1285 Washington Street,
Weymouth, MA 02189

Subject: 19 Highland Avenue
Randolph, MA 02368

The purpose of this letter is to respond to the Planning Director email comments dated August 31, 2022.

SECTION A-A
N.T.S.

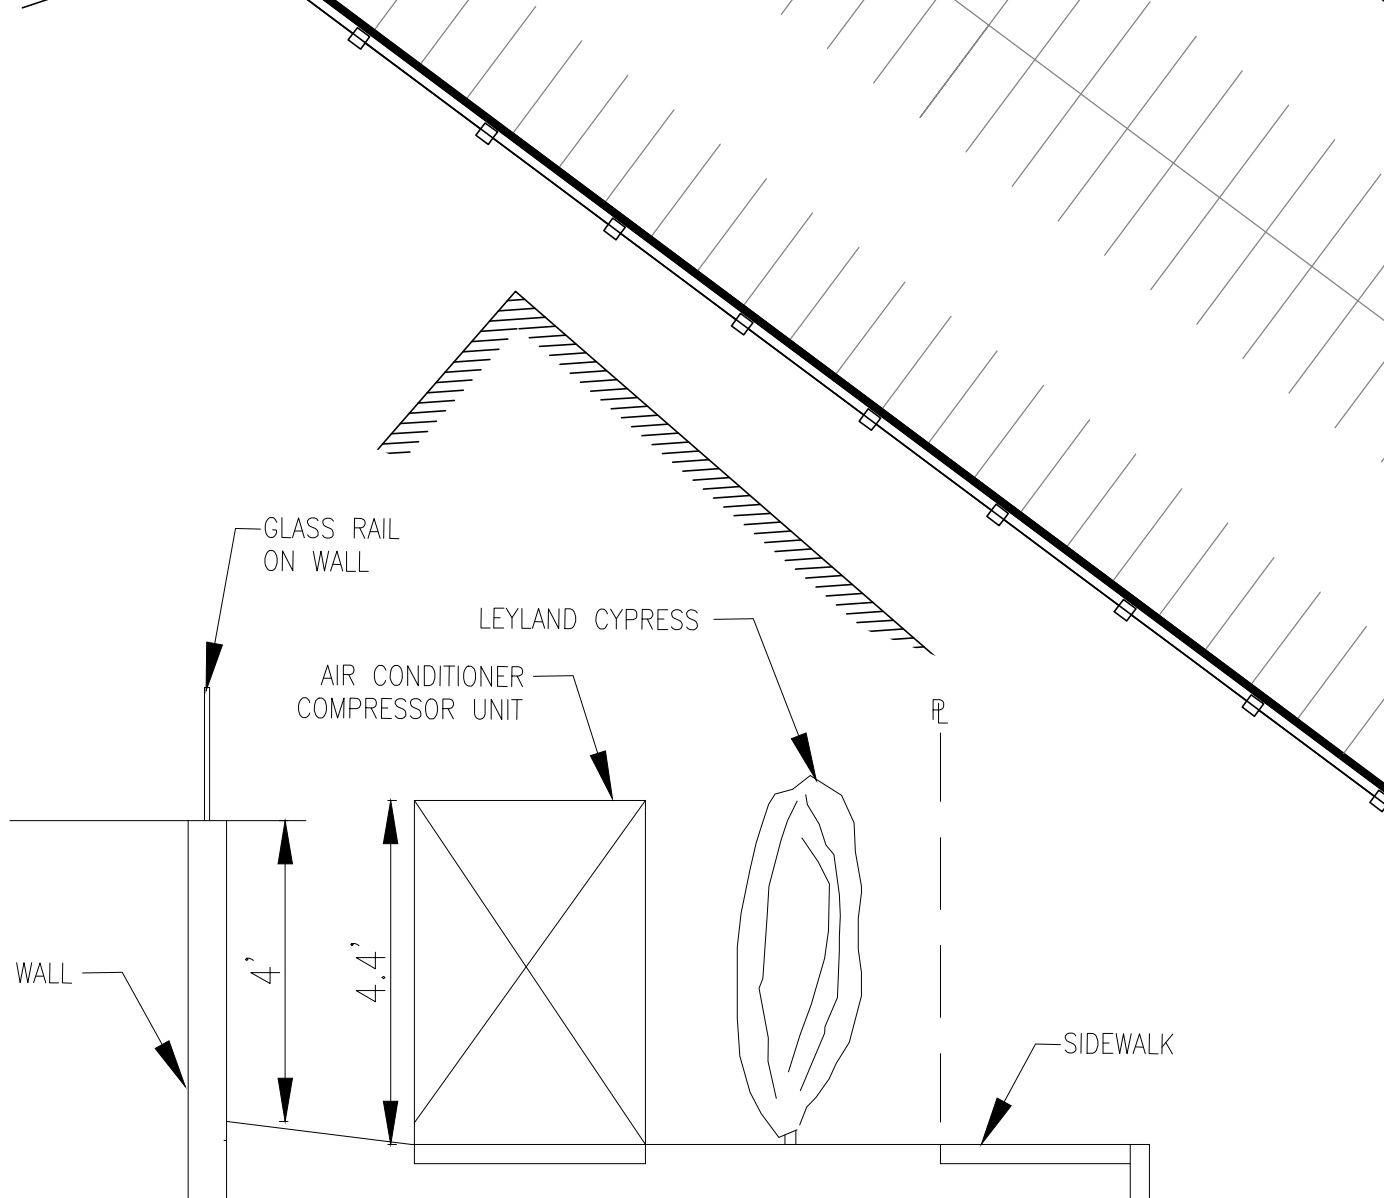
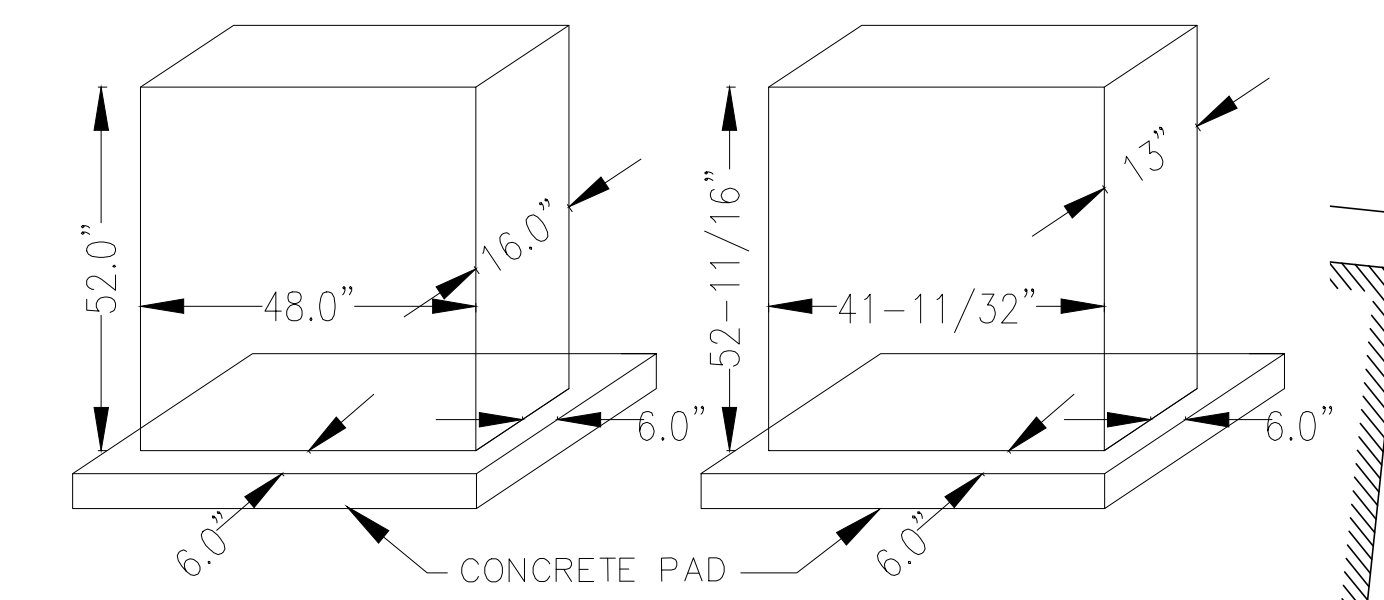
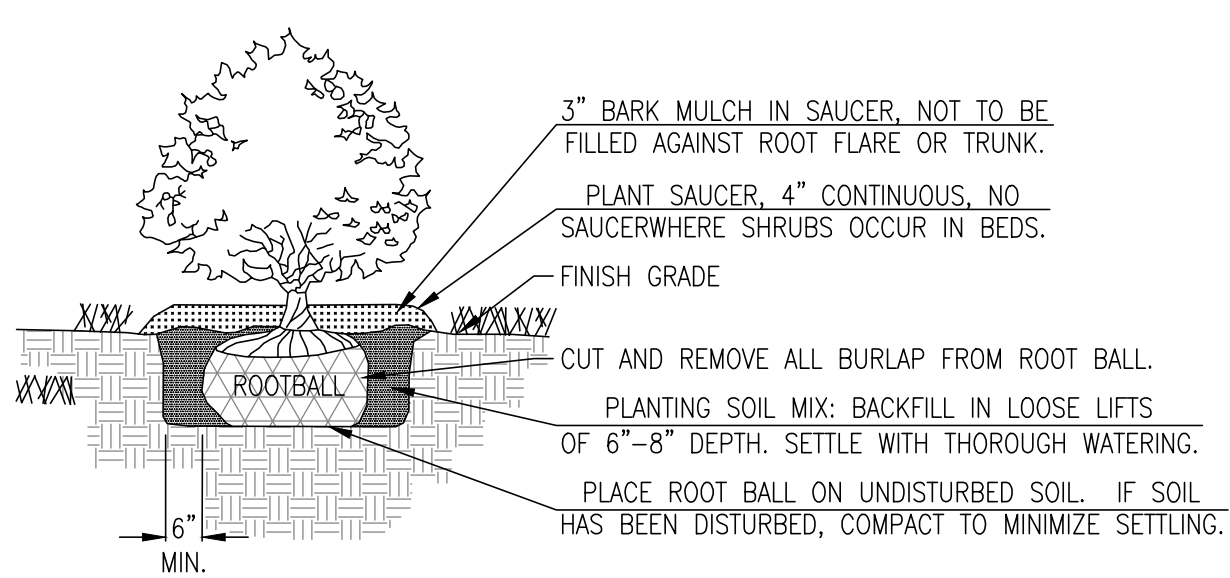
2) The tops of the refrigerated units should not be higher than the top of the retaining wall. Excavate down about 12" (or as needed) to pour the foundation in order to achieve this goal.

3) Relocate the refrigeration unit currently proposed near a first floor residential unit. It can be massed with the other 2 proposed units or in another area in front of the retaining wall and positioned as outlined in #2 above.

The top of the refrigeration and AC compressor units are to be set at the same height of the retaining wall. See revised sheet 7 Landscape Plan section A-A. A roll of Leyland Cypress evergreen plants is proposed in front of the units for screening the units from the sidewalk.

The top of the refrigeration and AC compressor units are to be set at the same height of the retaining wall. See revised sheet 7 Landscape Plan section A-A. A roll of Leyland Cypress evergreen plants is proposed in front of the units for screening the units from the sidewalk.

PICNIC TABLE SAMPLE
N.T.S.

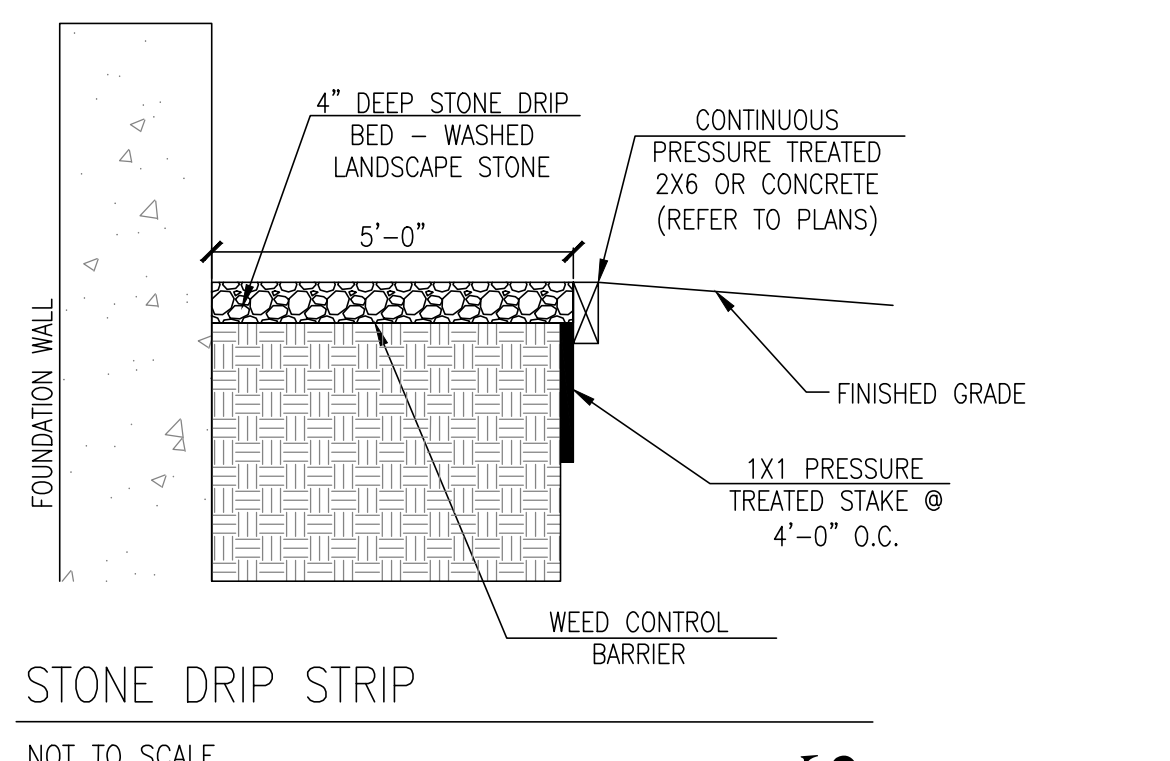
7) I reviewed the approved plans and there is, indeed, a picnic table amenity in the landscaped area at the rear of the building. There was significant conversation at the meetings about its specific placement and the Board agreed that there should be something there. The landscaped area is large enough to accommodate something. You may need to modify the landscape plan to incorporate some of the Leyland Cypress to provide a buffer between the dumpster enclosure and the amenity.

2 picnic tables and a concrete pad are added between the building and the dumpsters enclosure. Picnic table sample is shown on the Landscape Plan. 5 Leyland Cypress are added to screen the dumpster enclosure from the picnic area.
